# CONSTRUCTION PLANS FOR THE HILLS AT LORSON RANCH FILING NO. 3

## STREET & STORM SEWER CONSTRUCTION PLANS

**THE RIDGE AT LORSON RANCH FIL NO. 3  
STREET & STORM SEWER  
CONSTRUCTION PLANS**

DATE: NOV, 2021  
 PROJECT NO. 100.068  
 SHEET NUMBER C6.34  
 TOTAL SHEETS: 18

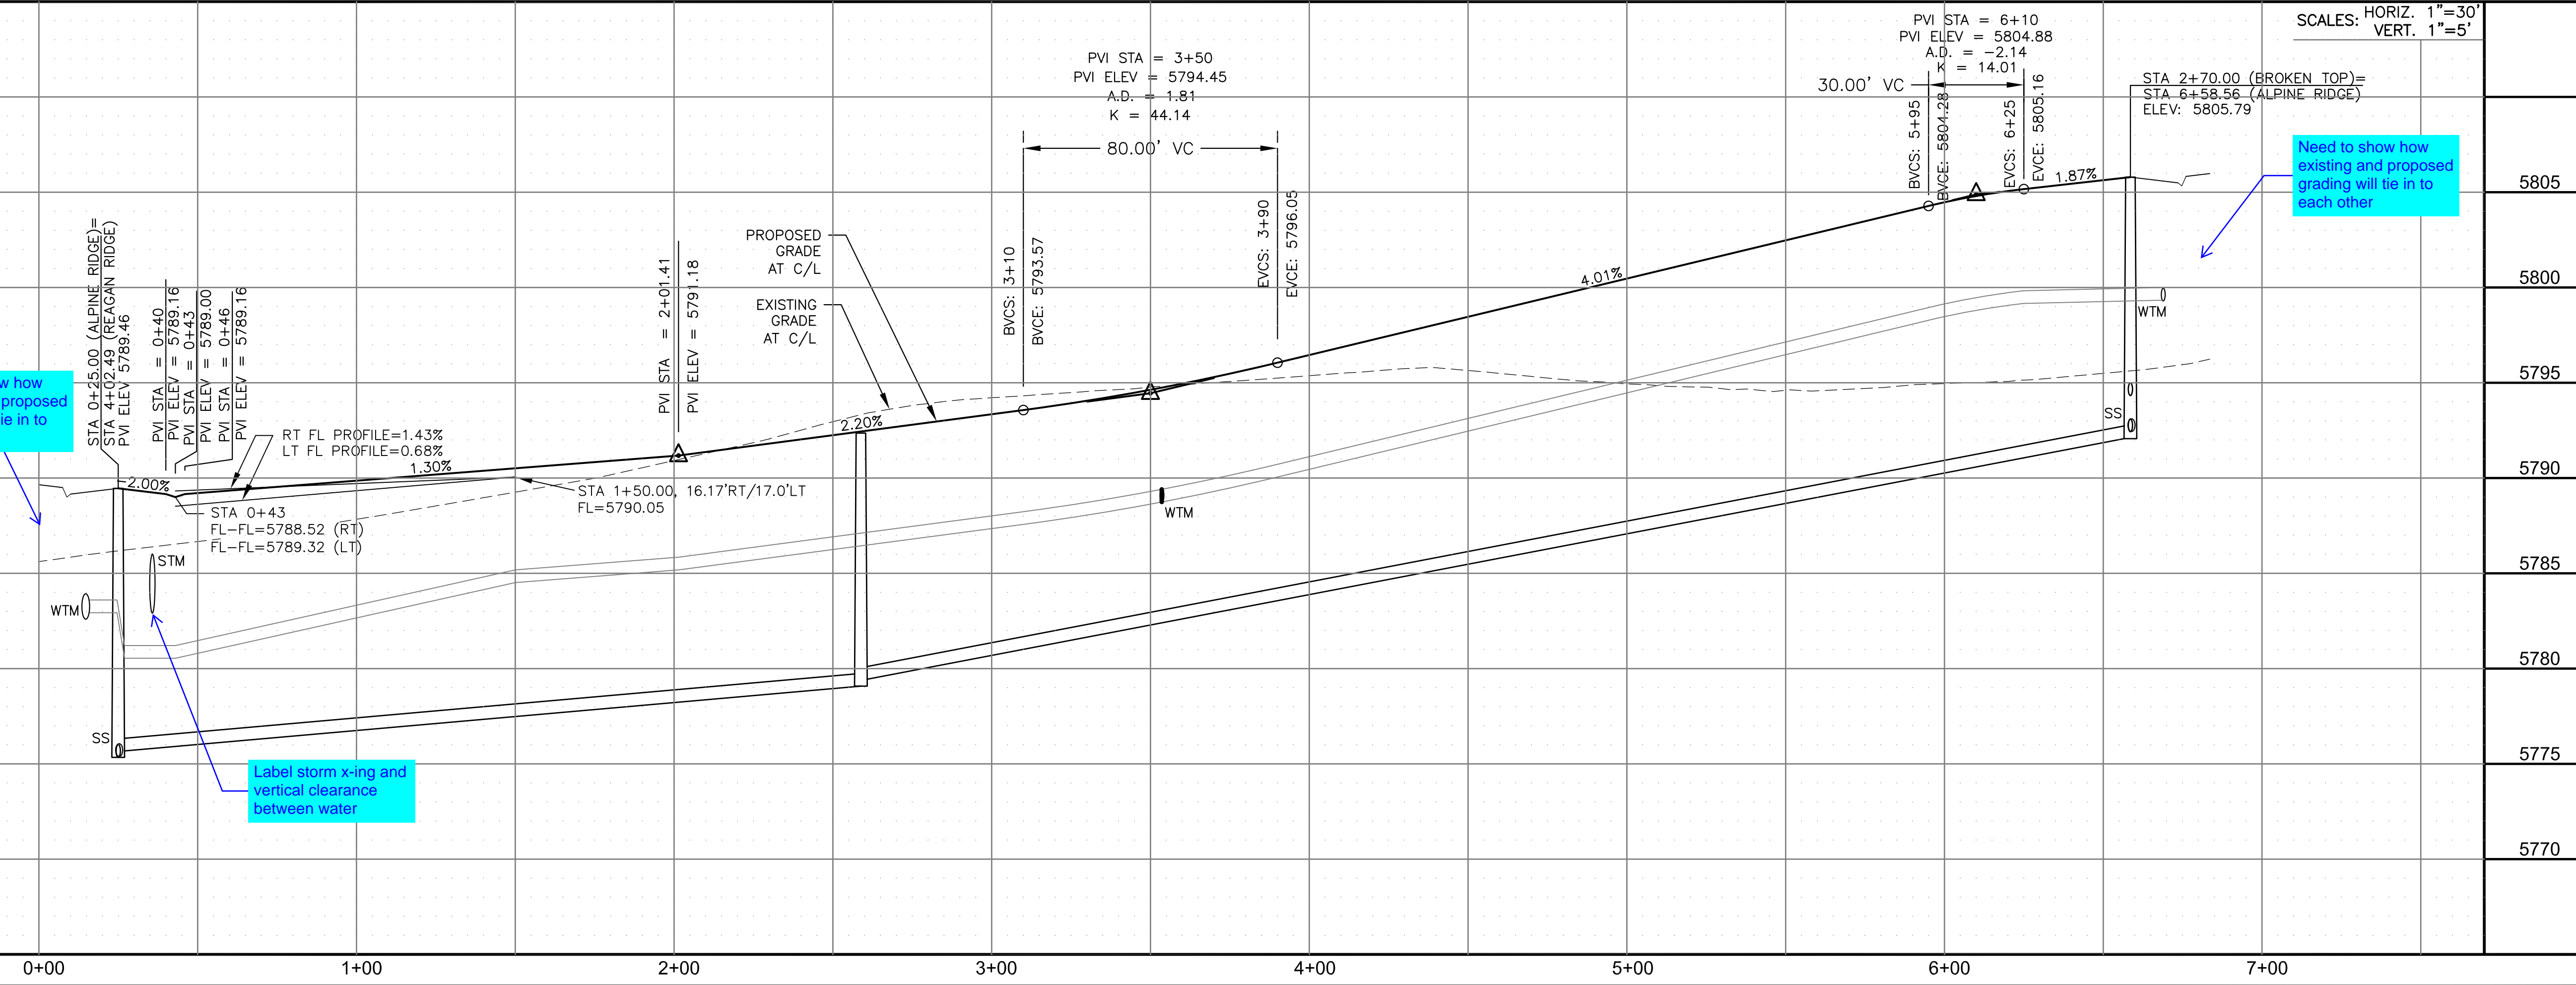
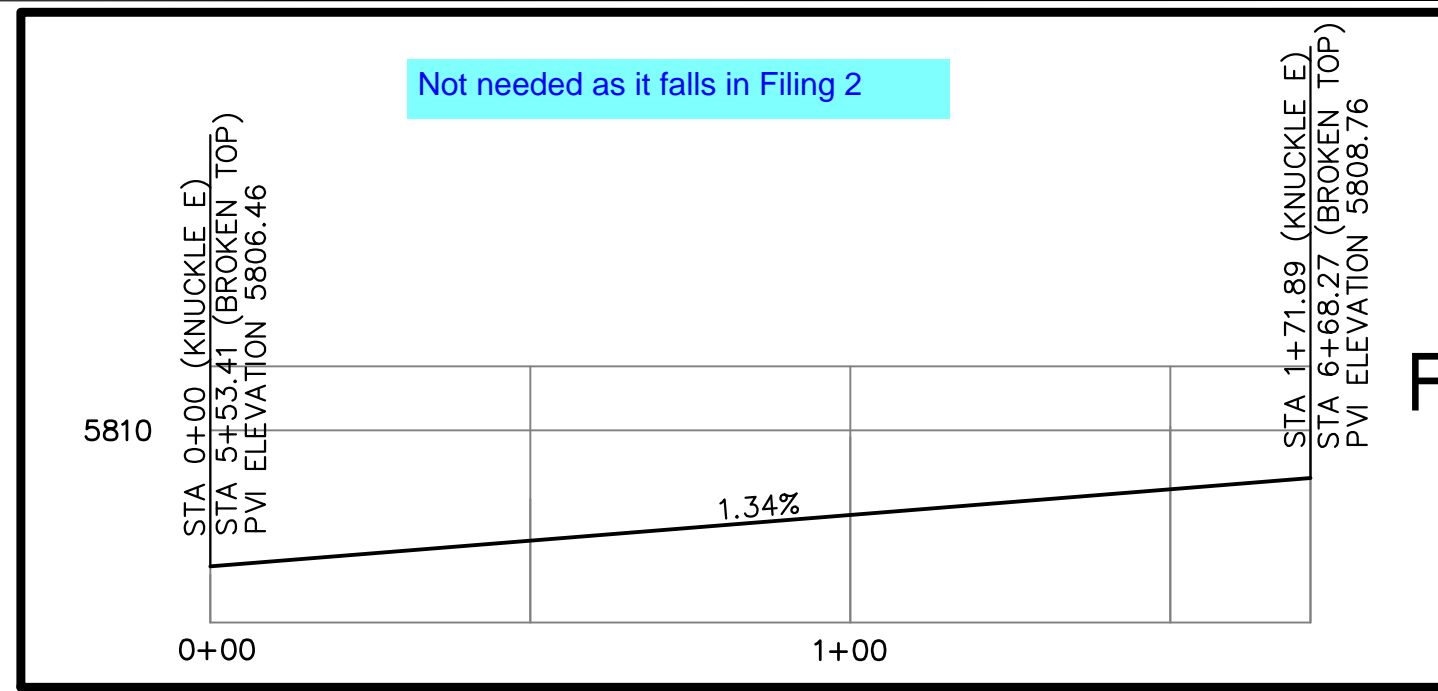
This sheet needs to be included in Filing 2 plan set for portion of road within that Filing.

DATE: NOV, 2021  
 PROJECT NO. 100.068  
 SHEET NUMBER C6.35  
 TOTAL SHEETS: 18

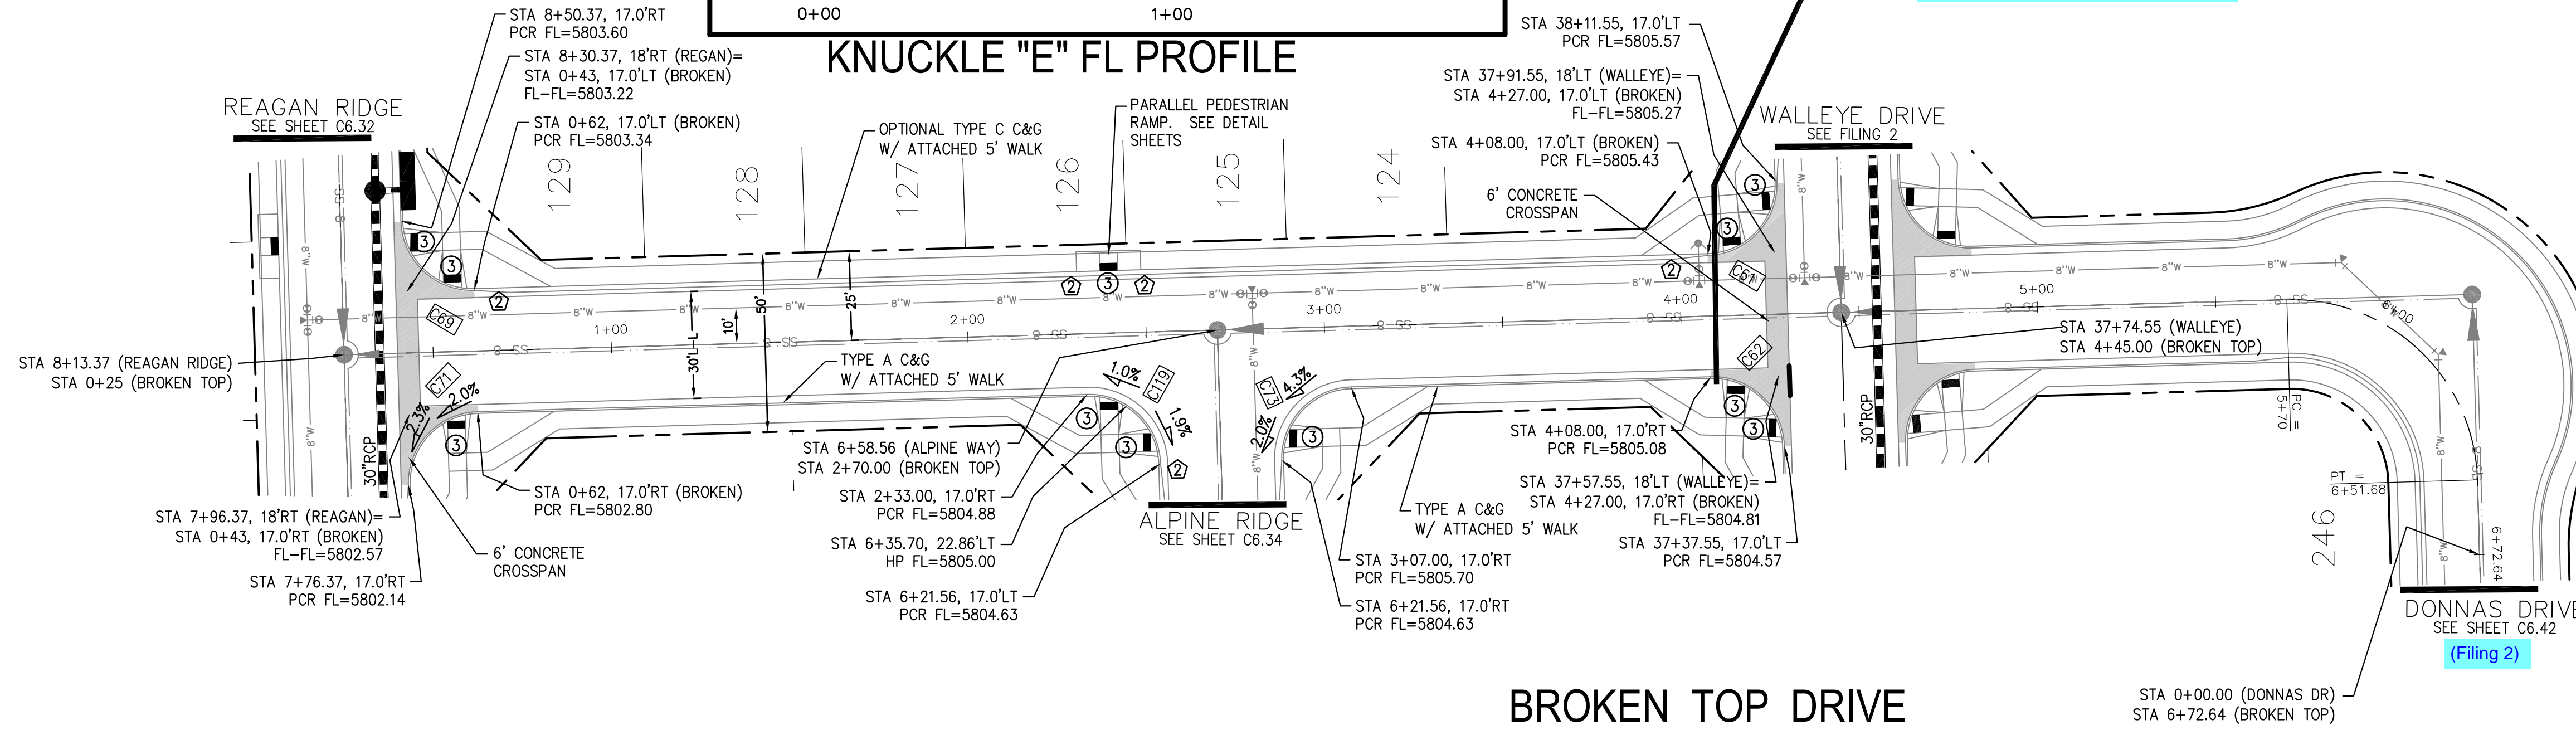
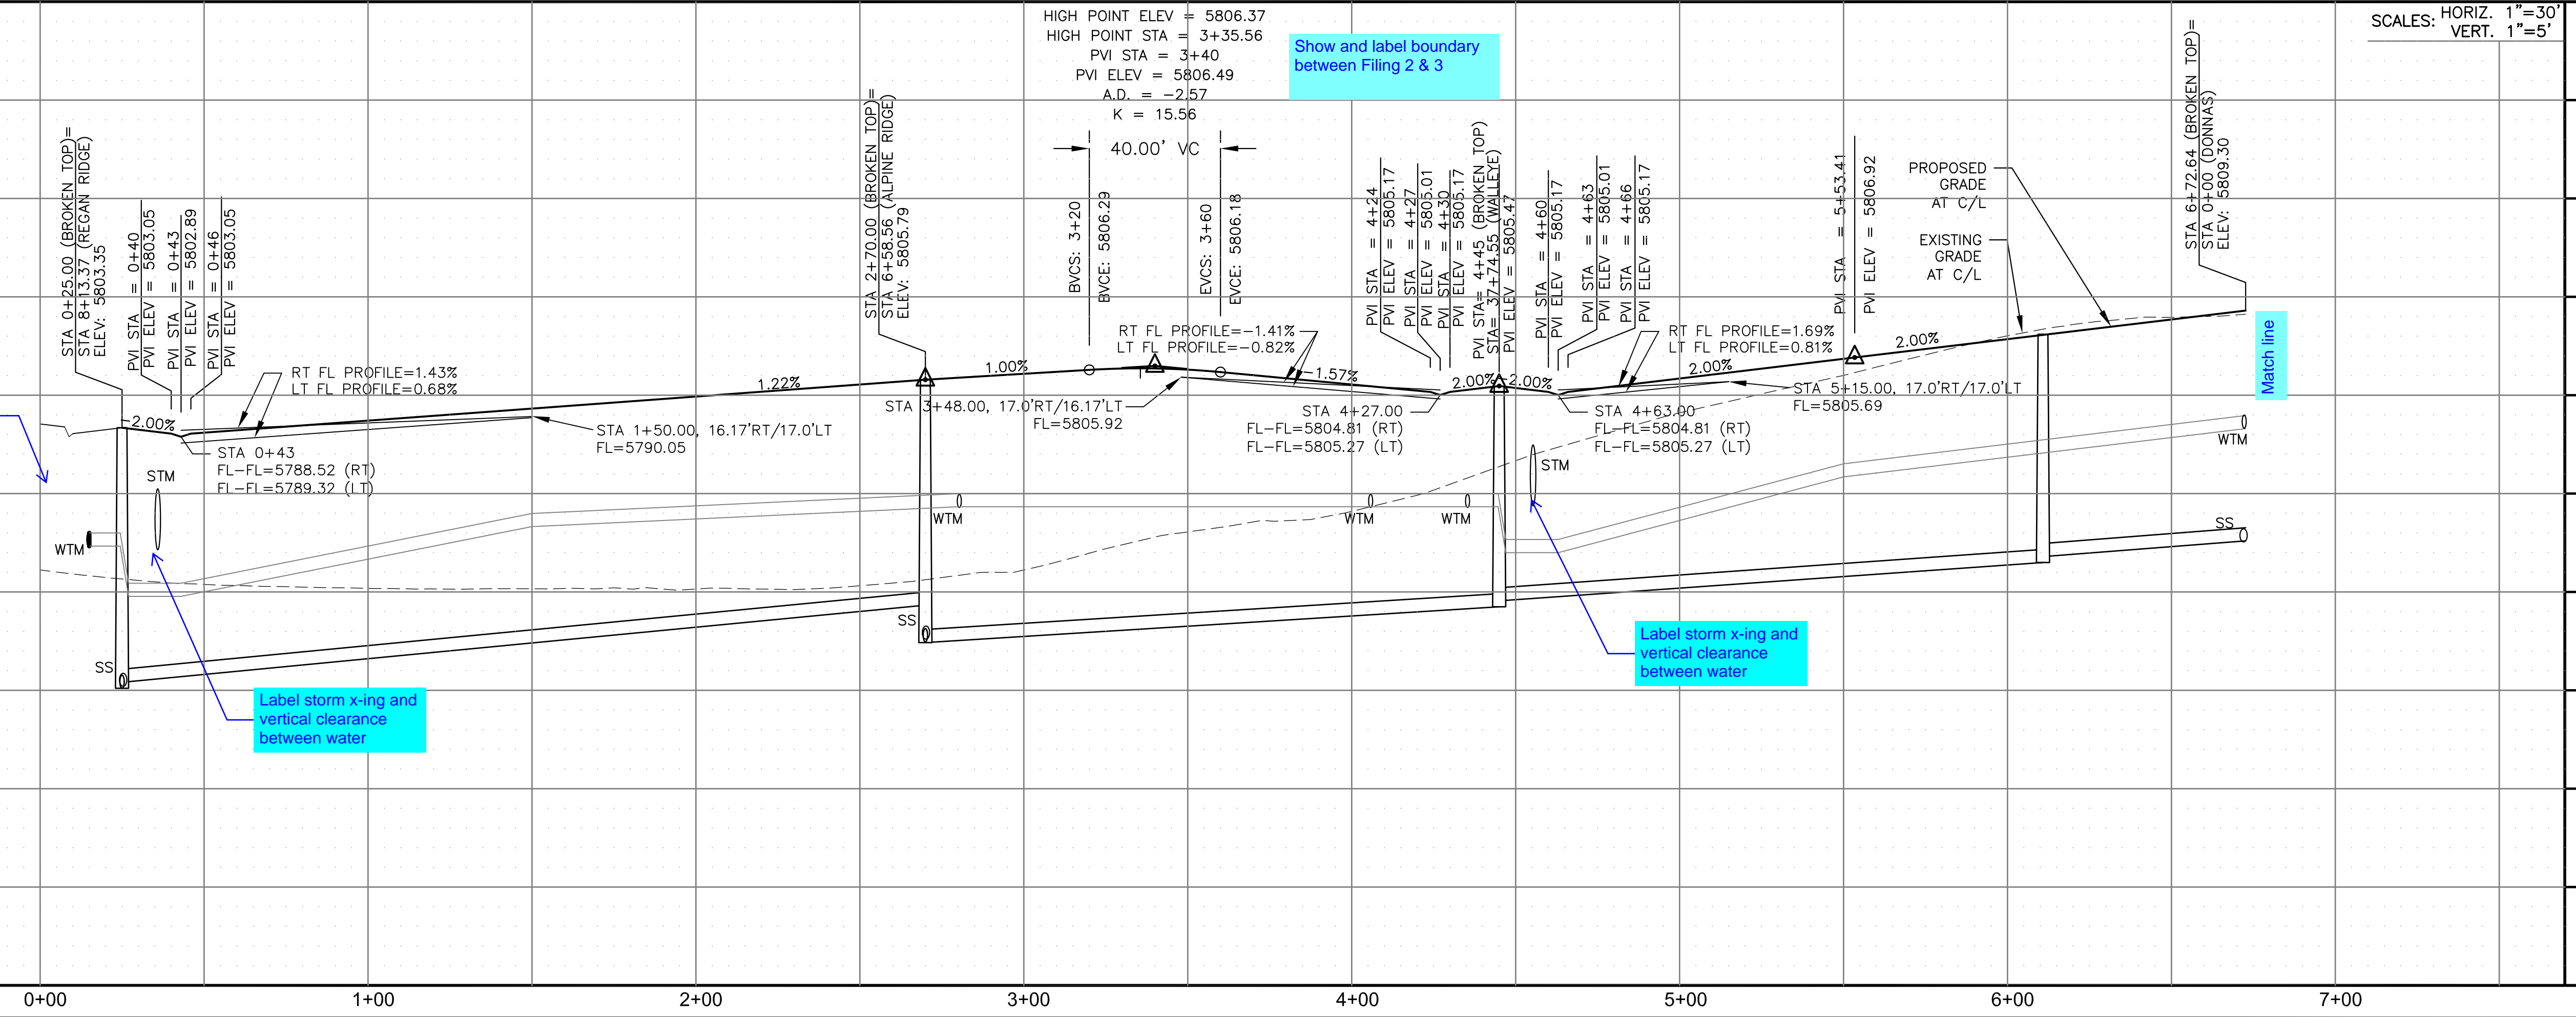
Need to show how existing and proposed grading will tie in to each other

Label storm x-ing and vertical clearance between water

Label storm x-ing and vertical clearance between water

Show and label boundary between Filing 2 & 3

SHEET NUMBER  
 C6.36

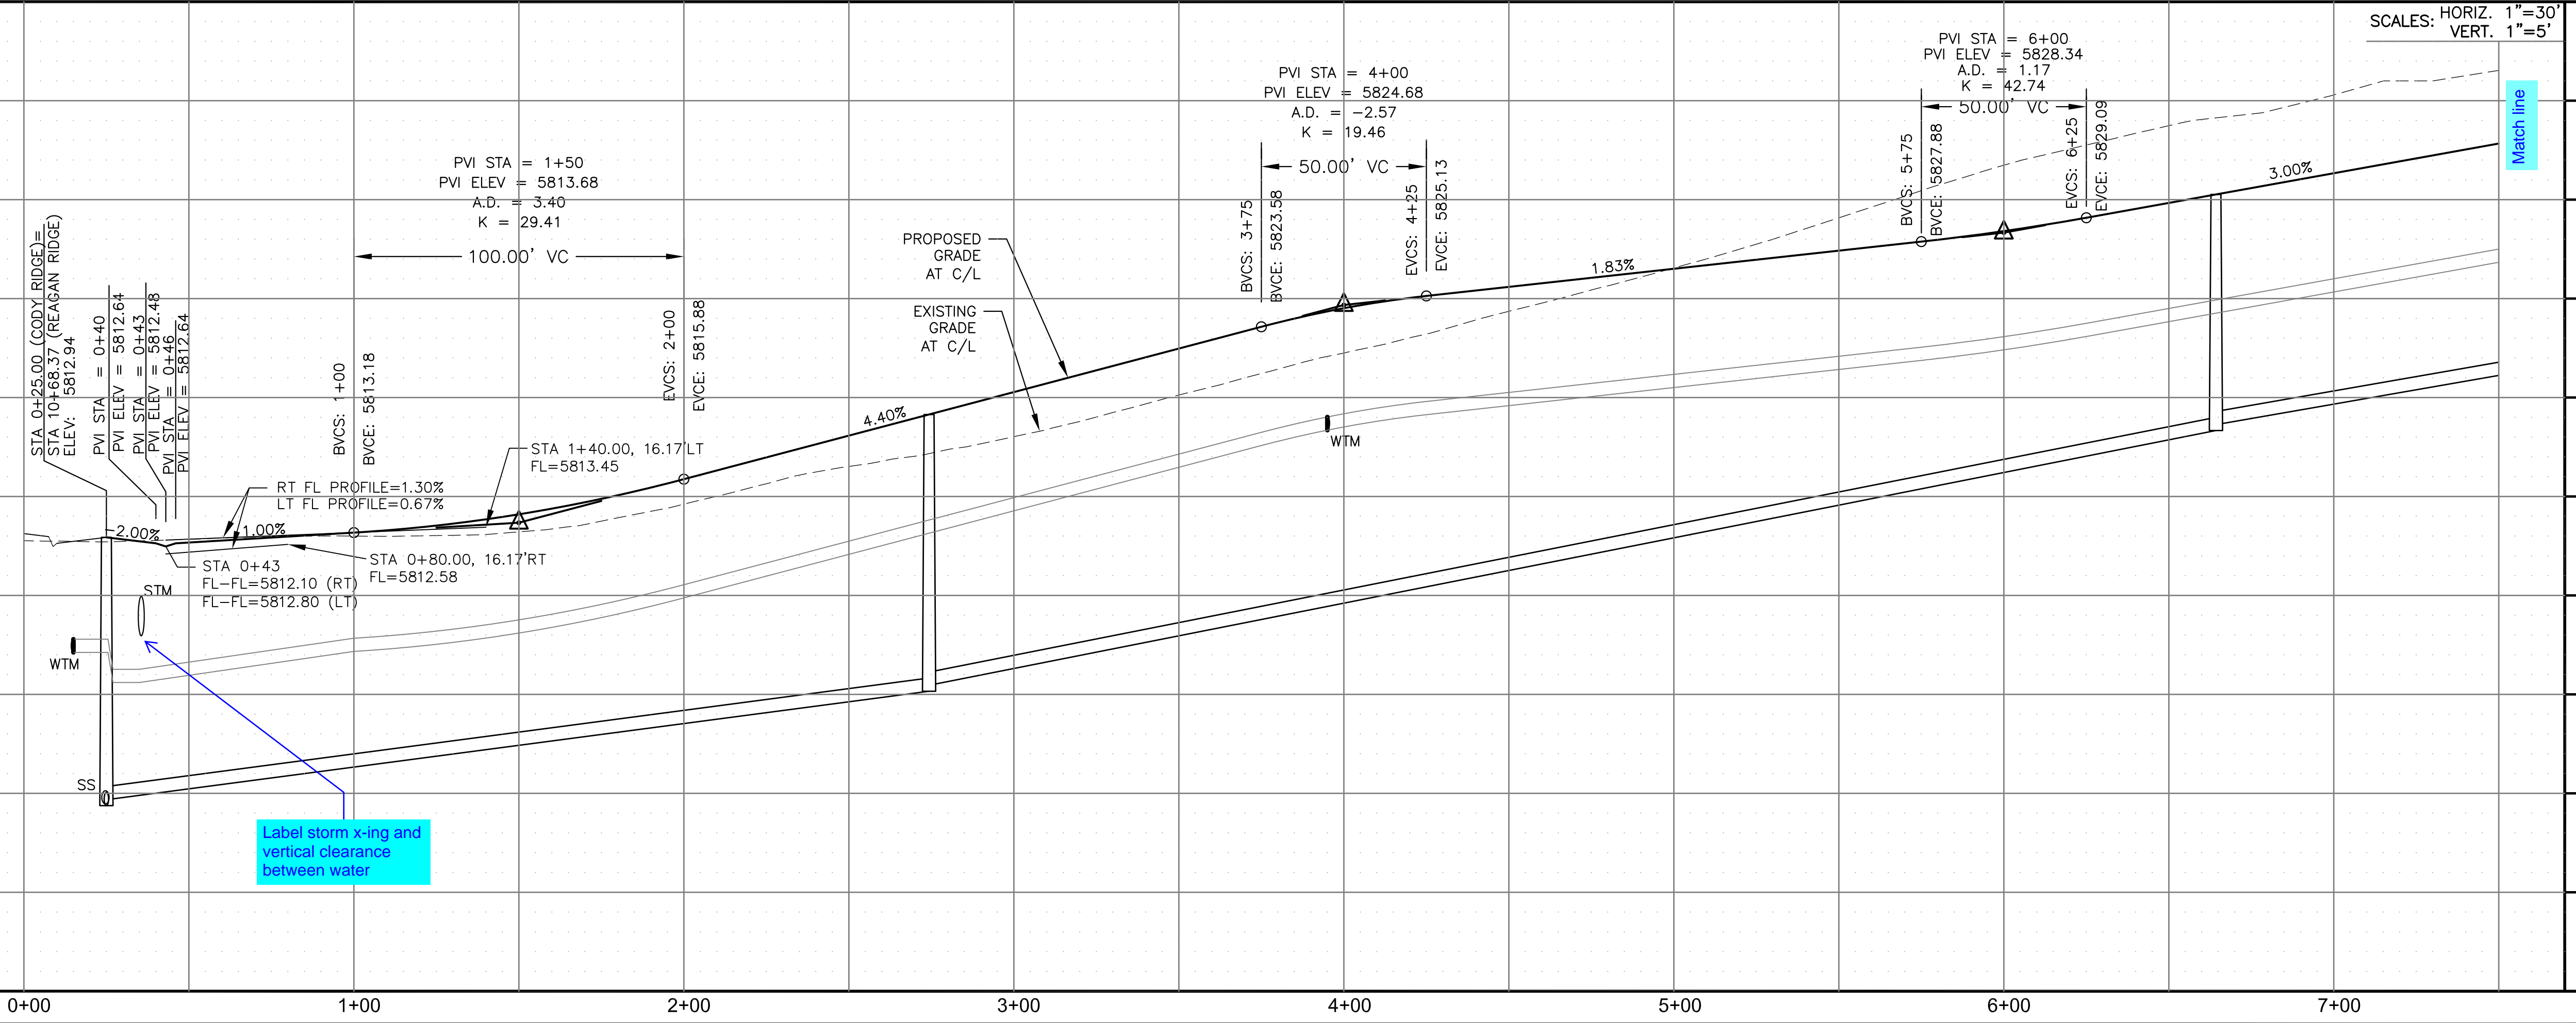
Label storm x-ing and vertical clearance between water
